ATTACHMENT 1

8212290252 821217
PDR ADOCK 05000338
P PDR

Figure 5.1-1

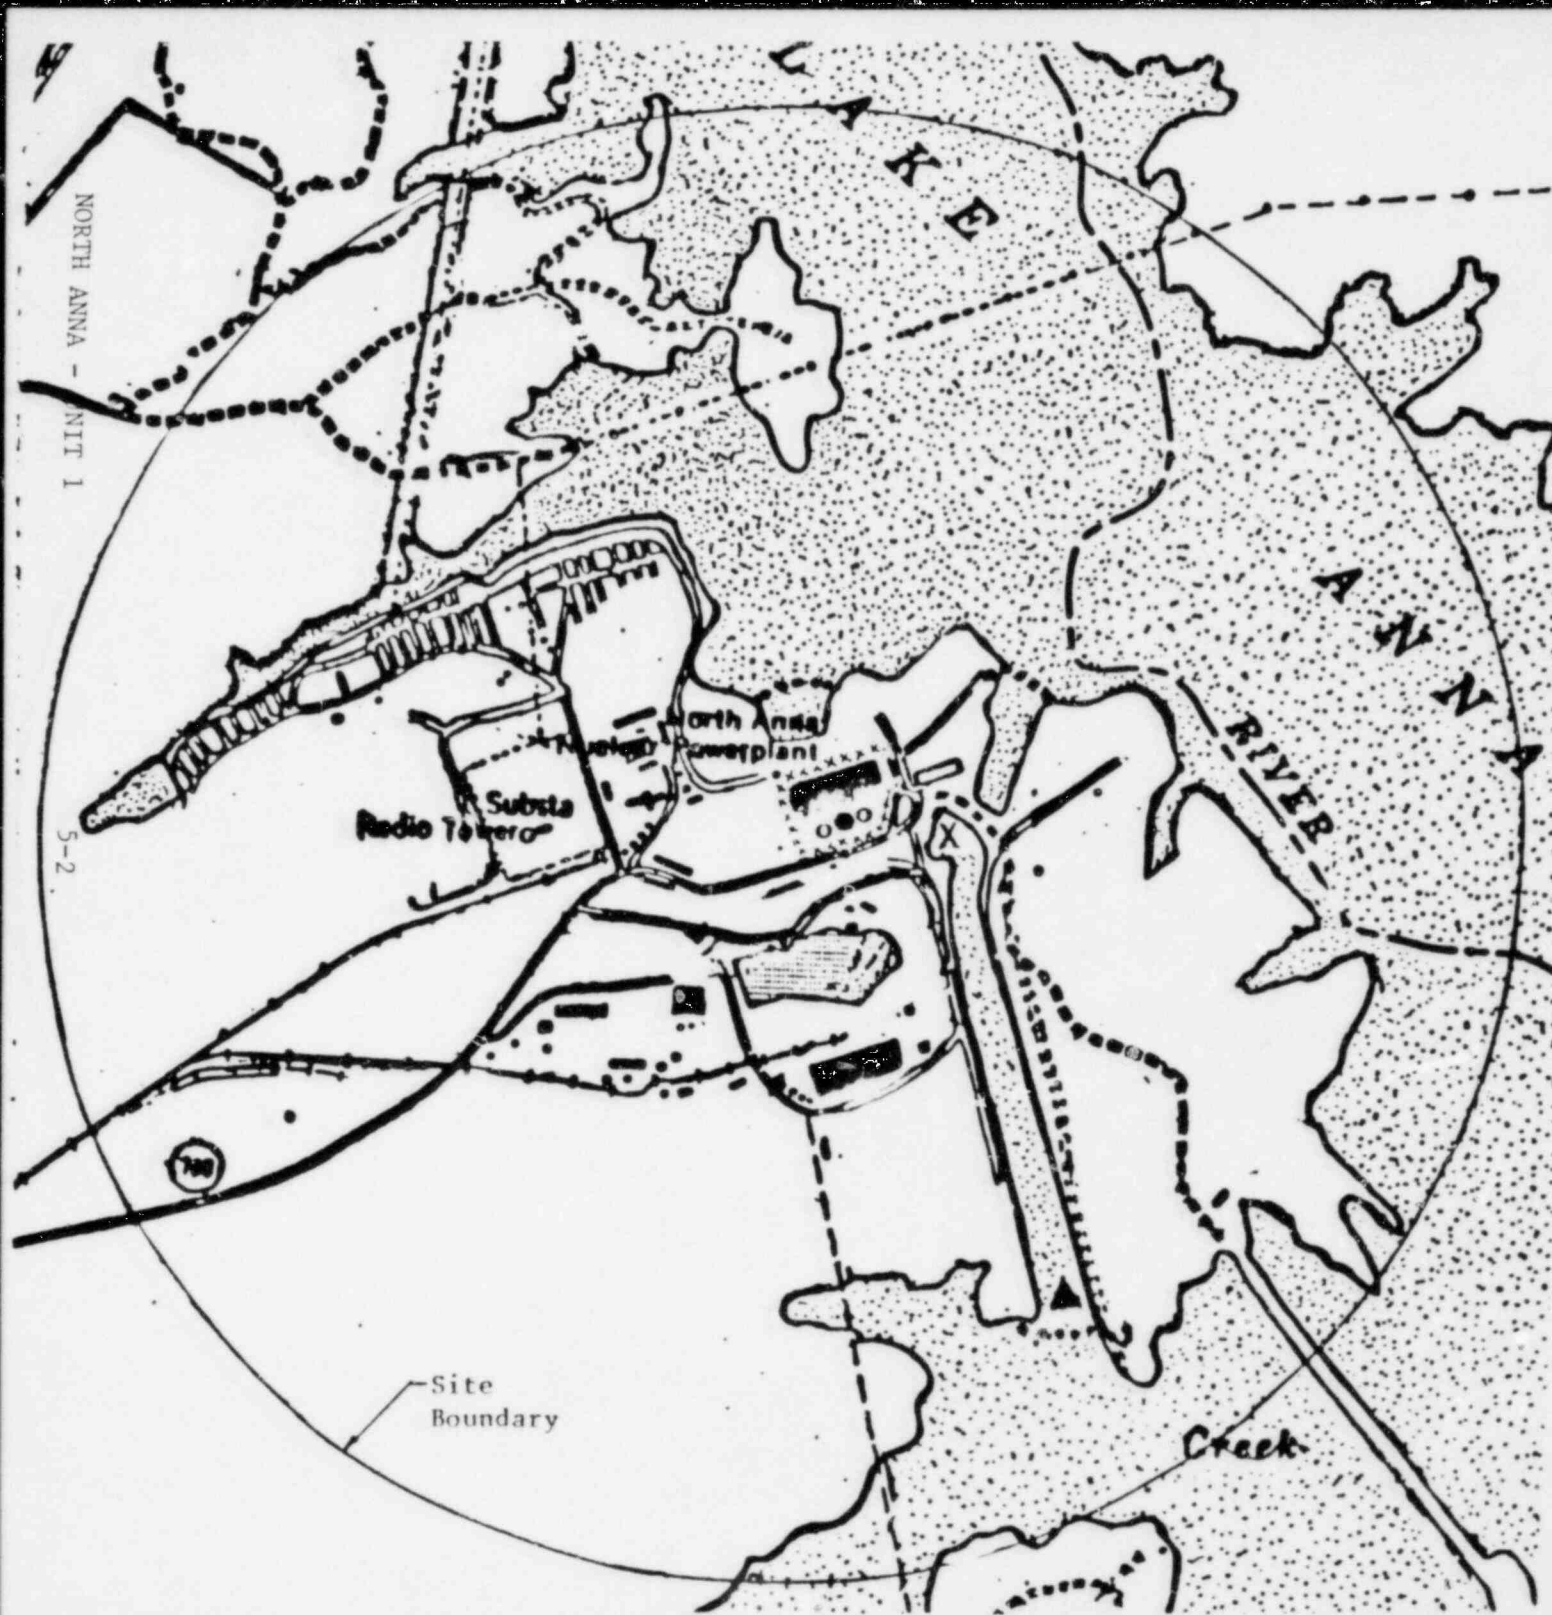
5.1.1 The exclusion area shall be as shown in Figure 5.1-1.

5.1.2 The low population zone shall be as shown in Figure 5.1-1.

5.1.3 Information regarding radioactive gaseous and liquid effluents, which allows identification of structures and release points as well as definition of UNRESTRICTED AREAS within the SITE BOUNDARY that are accessible to MEMBERS OF THE PUBLIC, shall be as shown in Figure 5.1-1.

Figure 5.1-1

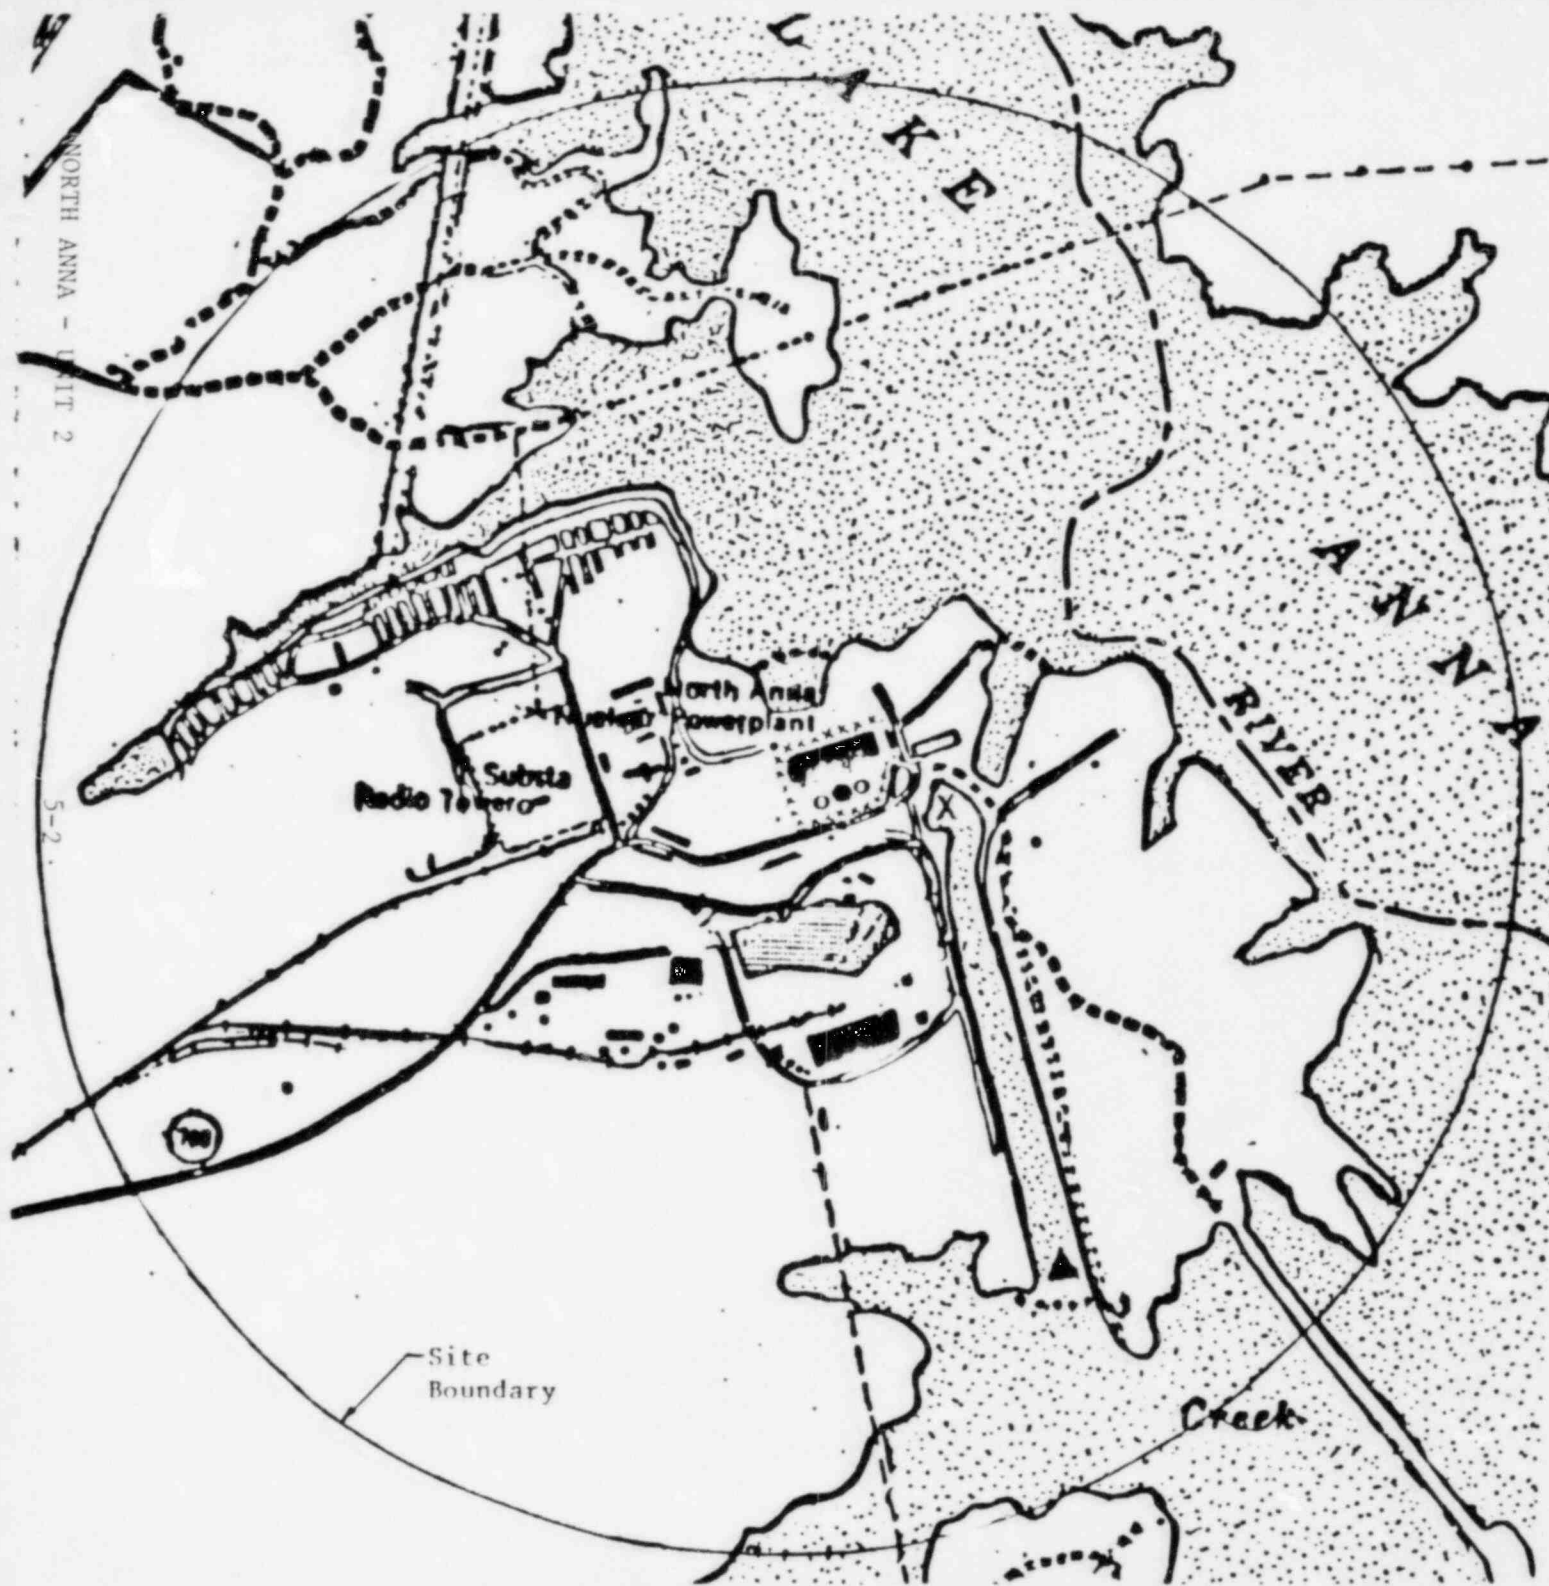
5.1.1 The exclusion area shall be as shown in Figure 5.1-1.

5.1.2 The low population zone shall be as shown in Figure 5.1-1.

5.1.3 Information regarding radioactive gaseous and liquid effluents, which allows identification of structures and release points as well as definition of UNRESTRICTED AREAS within the SITE BOUNDARY that are accessible to MEMBERS OF THE PUBLIC, shall be as shown in Figure 5.1-1.
